802.3 ca Contributions/Draft – COMMENTS
 Adriaan de Lind van Wijngaarden, Nokia Bell Labs, Murray Hill
 May 19, 2018

Description of the LDPC encoder and decoder – comments on the draft D1.0 clean, and han_3ca_1_0518.

Figure 142-3—FEC encoder

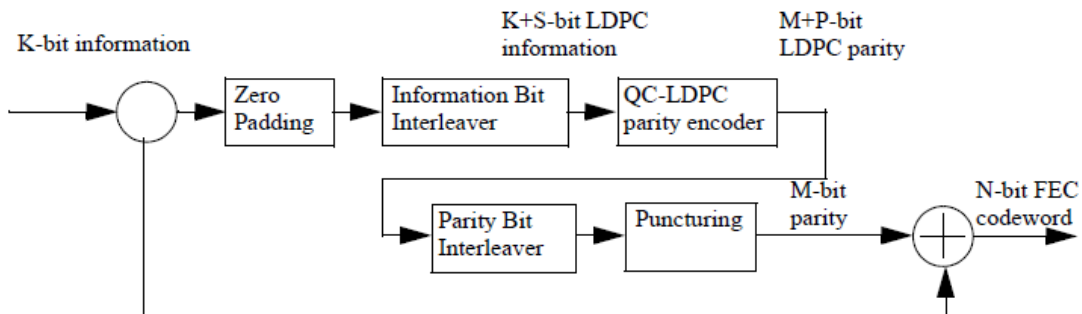
Comment A1. If the puncturing of parity is standardized, and if 256-bit segments are used, then it is not clear why parity bits are first interleaved and then punctured. It seems more straightforward to puncture the two full 256-bit segments, and then to perform bit interleaving.

Comment A4. The FEC decoder figure in han_3ca_1_0518 should be improved; as shown in Fig. 142-3, the information bits are interleaved prior to entering the LDPC encoder, but they are transmitted non-interleaved. Therefore, the information portion of the received word should be “**interleaved**”, and the (interleaved) information portion at the output of the LDPC decoder should be “**deinterleaved**”.

Figure x1 – FEC decoder

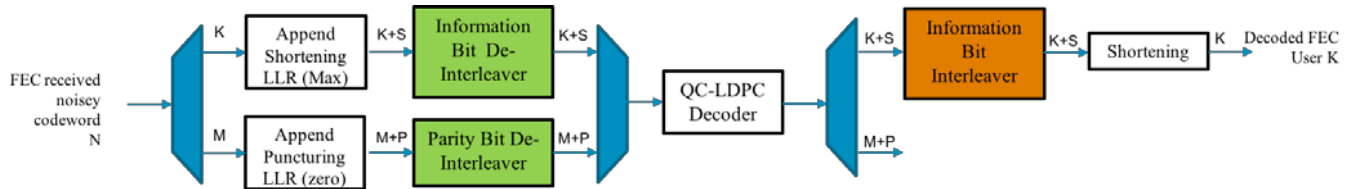
Comment A5. There are several other inaccuracies in Fig. x1. For instance, “FEC received noisy codeword N” is a bit ambiguous. For the downstream direction, the length is indeed fixed, but for the upstream, it is not. I am not sure whether this will be described separately. In the upstream, one would need to know the length of the received word, and then append zeros after the information part. On the right-hand side, it is not clear whether the intention is to also output parity check bits (there is an arrow with (M+P) segments. It is also strange to reuse the parameter K in the label “Decoded FEC User K”.
